Re: Proposed Hidden Quarry  
Noise Impact Study Report Addendum #1

This letter serves as addendum #1 to the Noise Impact Study<sup>1</sup> for the proposed Hidden Quarry development to address the following:

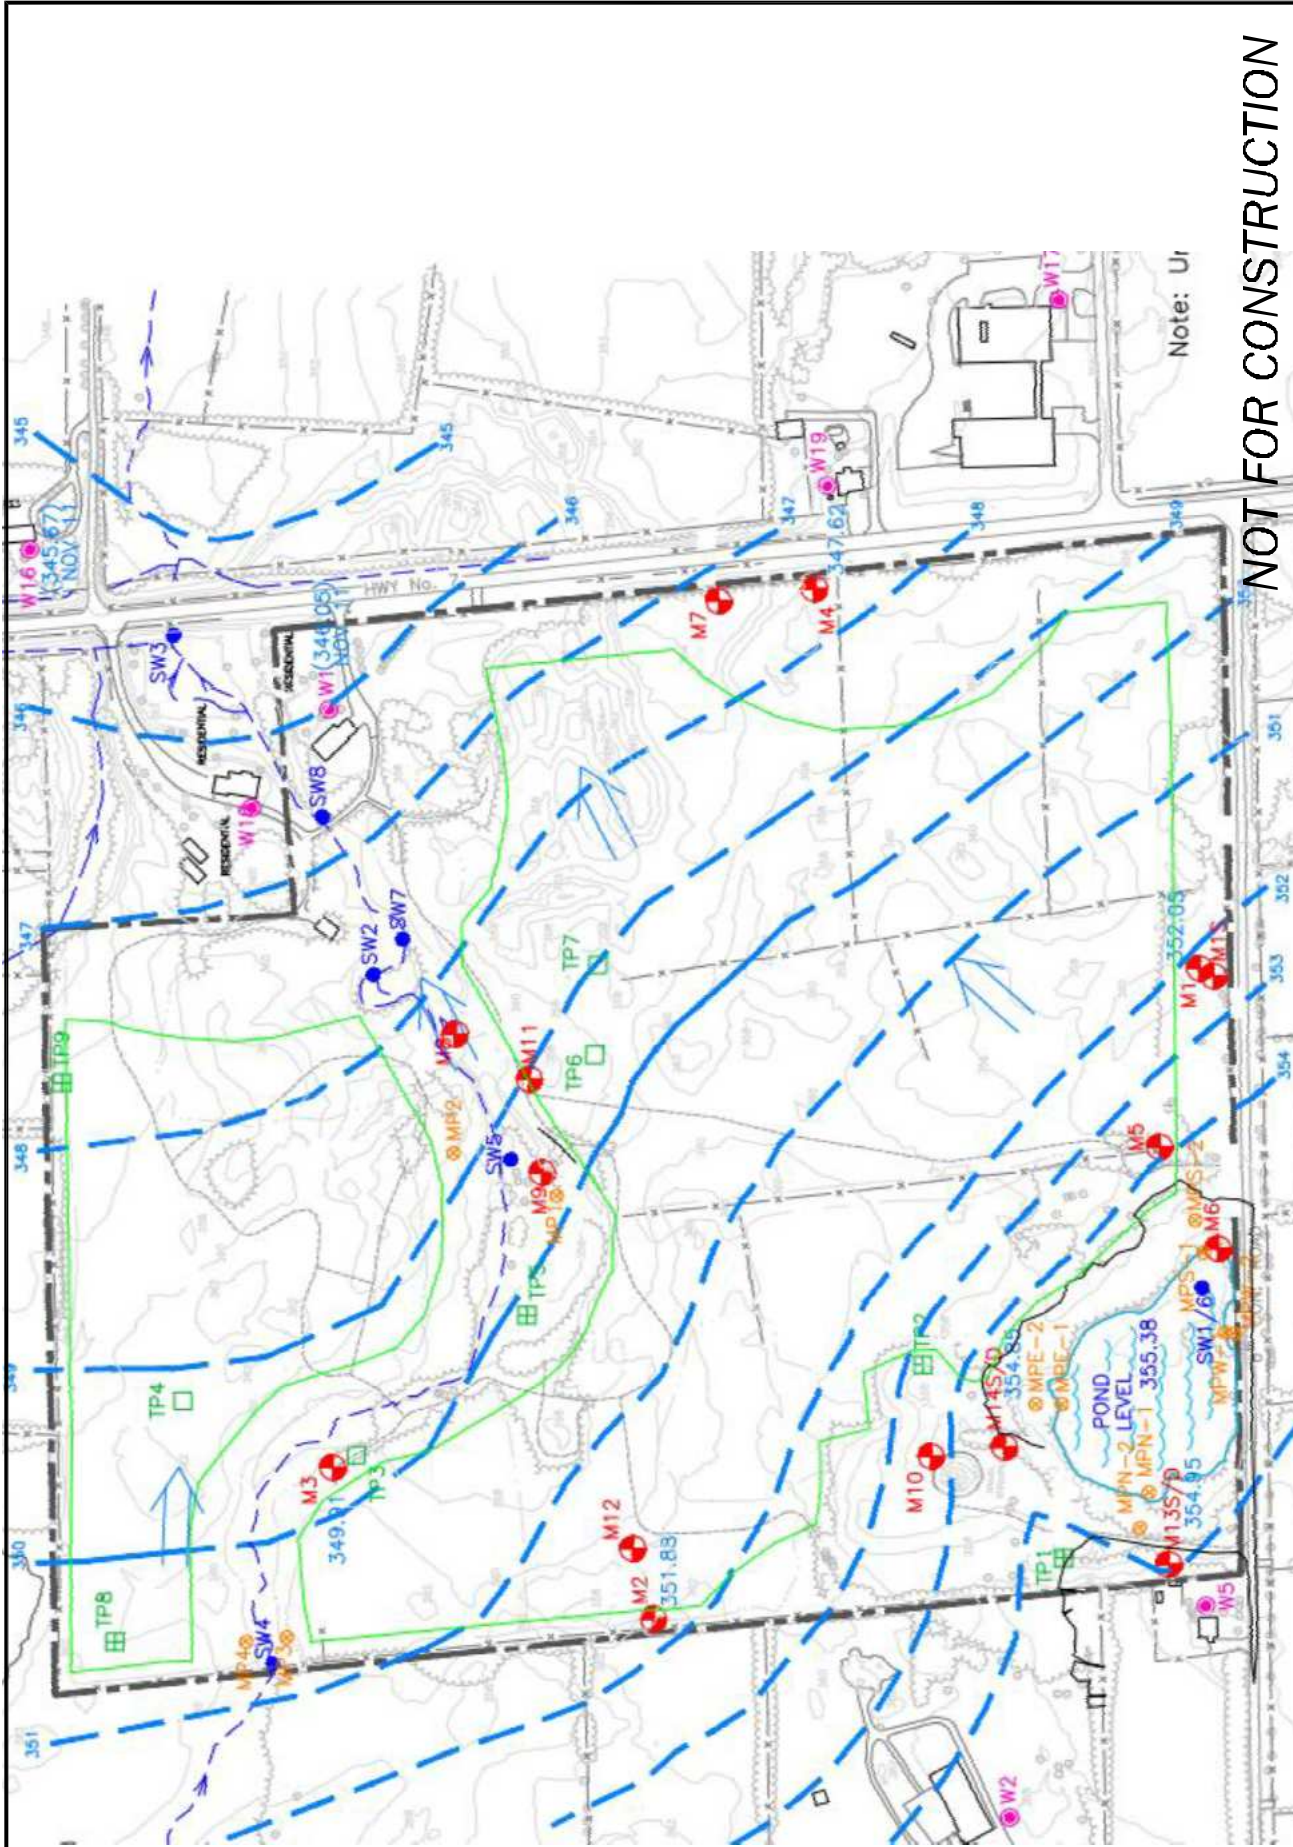
1. Revised quarry floor elevation height for high spring water elevation level  
The high spring water level was measured to range from 346 masl to 354 masl across the site as shown in Figure 1. In the vicinity of the process plant location the high spring water level elevation is around 350 masl.

A revision to the noise model was required to accommodate the quarry floor remaining above the high water table, specifically in the processing plant area where the quarry floor has increased from 349 masl to 351 masl. The noise model used conservative quarry floor levels of 355 masl in phases 1 and 3 and 354 masl in phase 2.
2. Changes to on-site truck haul routes for phases  
On-site truck haul routes for Phases 1, 2 and 3 have been updated based on the latest site plan.
3. Updated location of processing plant and stockpile locations  
A minor reposition of the processing plant and stockpiles was implemented in the model to reflect the location shown on the latest site plan.

Figure: 2

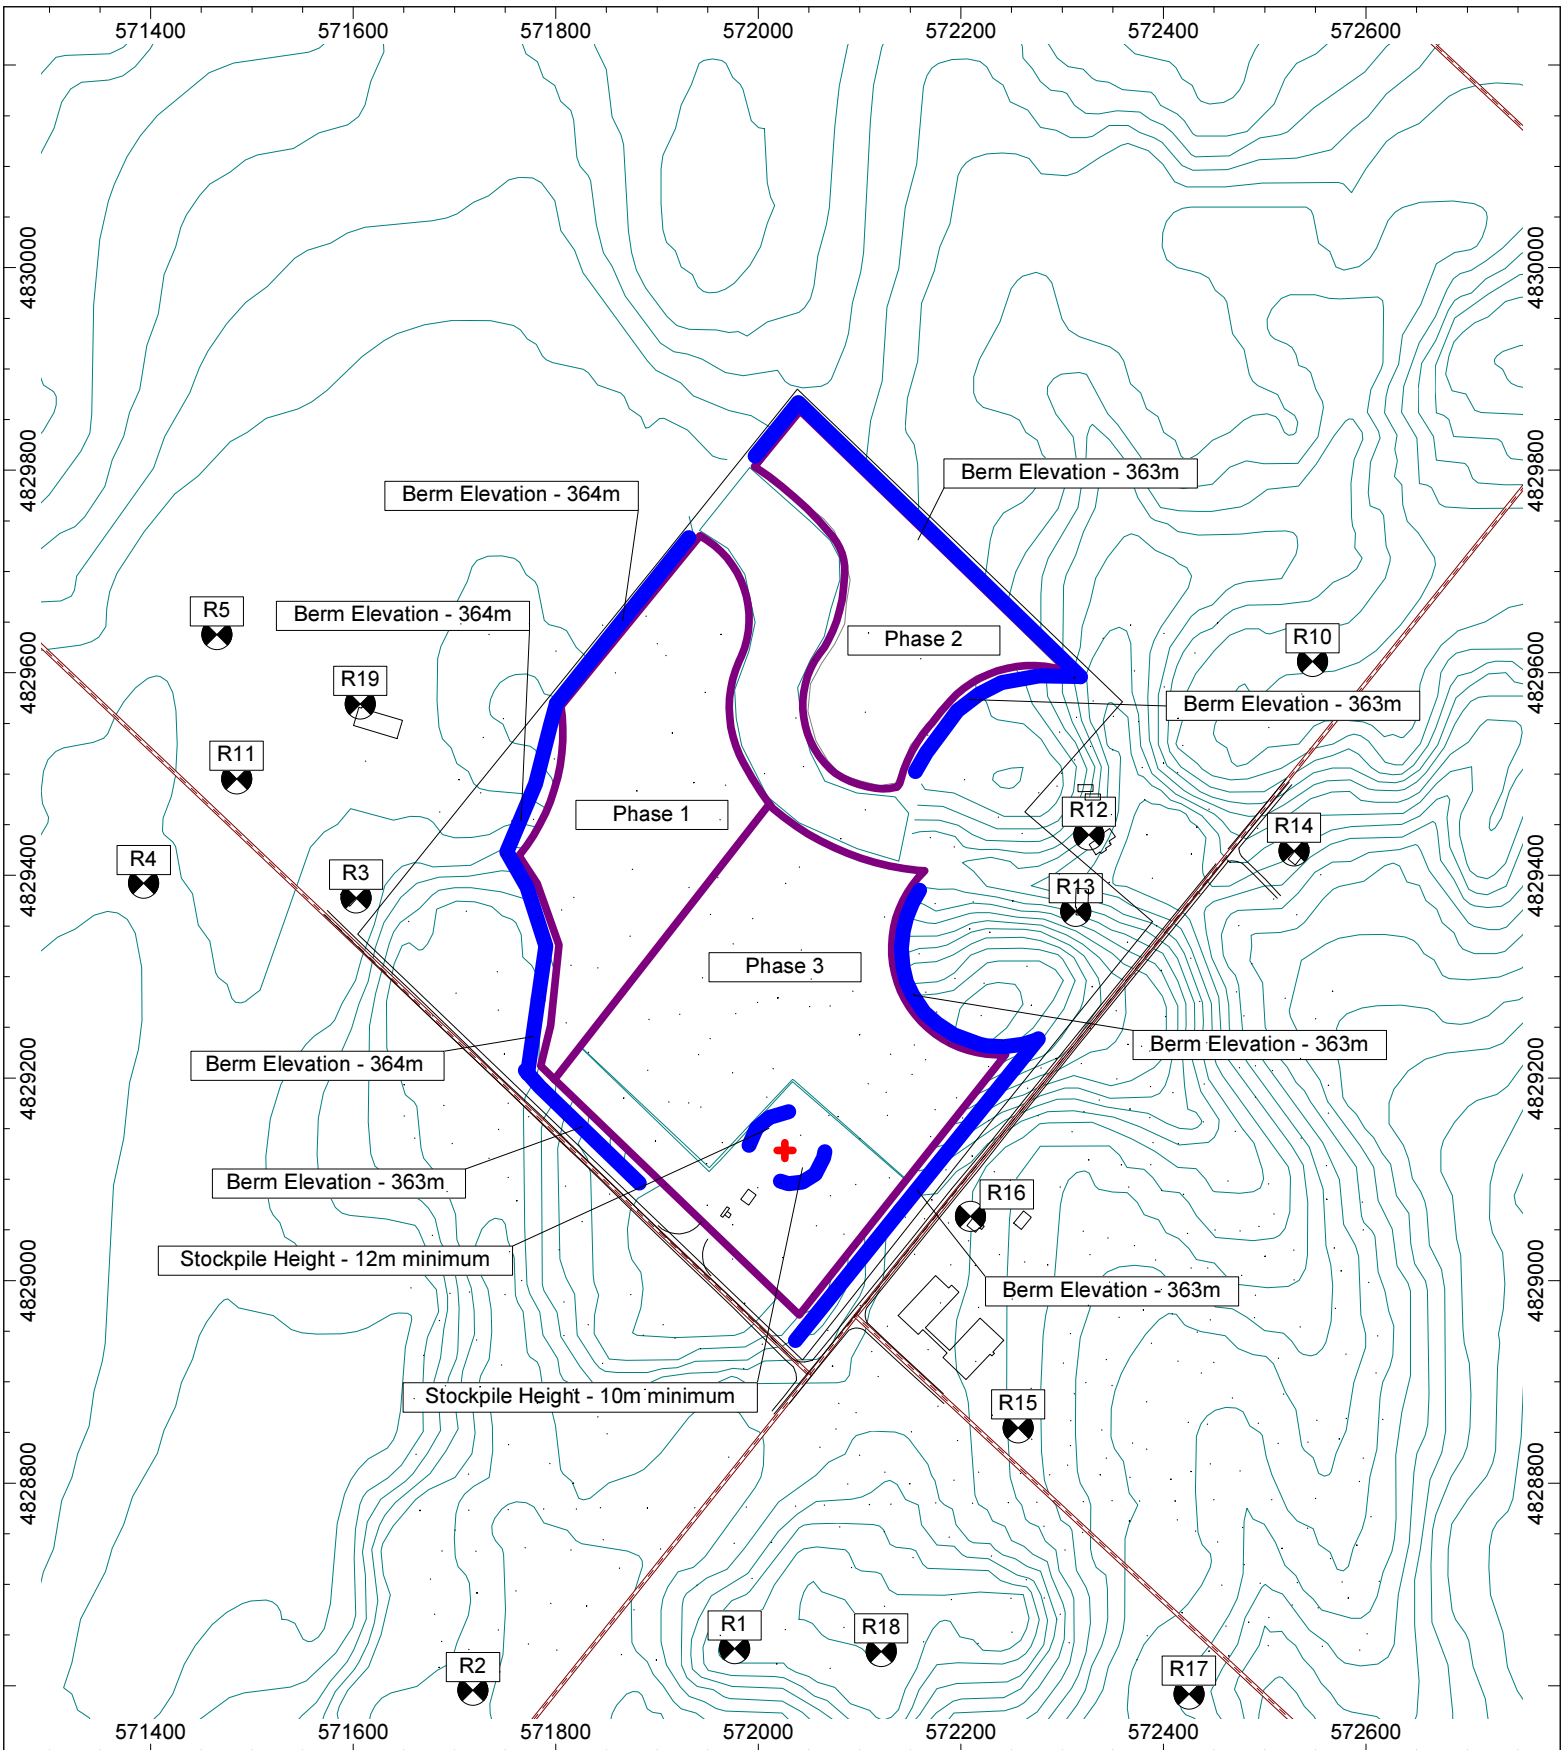
- 1) Quarry floor in the vicinity of the processing plant was changed from 349 masl to 351 masl.
- 2) The east portion of the 12 m stockpile shown on the site plan adjacent to the processing plant was extended to provide screening for R7.
- 3) Removal of recommendation for direction of extraction. There is no requirement to use the working face as a noise control measure. Perimeter berming is will provide sufficient screening.

1. 12m and 10m high stockpiles should be maintained in certain locations around the processing plant for each phase and stage. The stockpile peaks should be located no further than 30m from the processing plant, and should be located such that, in plan, they block line-of-sight between processing plant equipment and sensitive receptors, as described in the table below:

This configuration is shown in Figure 2.

2. A quiet drill with a maximum sound power rating of 112dBA should be used. This corresponds to a maximum sound pressure level rating of 75dBA at 30 meters.
3. Earth berms should be constructed to the elevations shown and located as shown on Figure 2.
4. The processing plant area should be established at an elevation of 351m, and a haul route trench connecting the processing plant area to the Stage 1 Phase 1 extraction area should be excavated to the same 351m elevation.
5. All construction equipment used in site preparation/construction must meet the sound emission standards defined in MOE publication NPC-115 and
